**COMMENTS ON USED COOKING OIL BIODIESEL
CALIFORNIA GREET MODEL
FOR THE
LOW CARBON FUEL STANDARD DEVELOPMENT**

**National Biodiesel Board
605 Clark Avenue
Jefferson City, MO 65110-4898**

(S&T)² Consultants Inc.
11657 Summit Crescent
Delta, BC
Canada, V4E 2Z2

Date: August 5, 2009

Figure 2-1 Basic Biodiesel Reaction

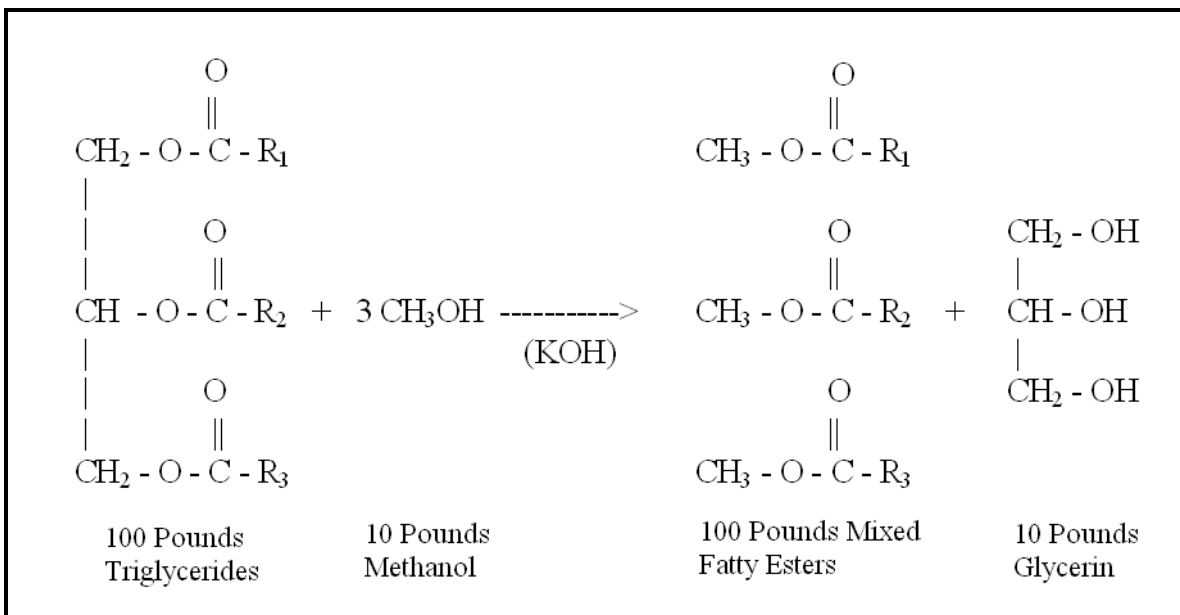
The GREET model has mass balance for biodiesel production that is based on the NREL biodiesel LCA that was undertaken during the 1990s. The model assumes that the quantity of glycerine that is produced is 21.3% by weight of the quantity of biodiesel produced. This value is incorrect, both from considering the stoichiometric ratio for the biodiesel reaction and from the industry experience.

The basic biodiesel reaction is shown in the following figure. One hundred pounds of triglycerides reacts with 10 pounds of methanol to produce 100 pounds of biodiesel and 10 pounds of glycerine.

The value that was reported in the NREL report and adopted by GREET was probably the quantity of crude glycerine produced. This would be a combination of water, glycerine, salts, and perhaps some methanol. It has considerably different chemical properties than pure glycerine. The glycerine properties that are included in GREET are those for pure glycerine.

The impact of the error in the CARB documents is small and it results in an underestimation of the GHG emissions for all biodiesels. When it is eventually found it will reduce the credibility of the significant reduction in GHG emissions that are provided by biodiesel fuels. It is very easy to correct this values in GREET. Cell C39 on the BD sheet needs to be set to 0.10 instead of 0.213.
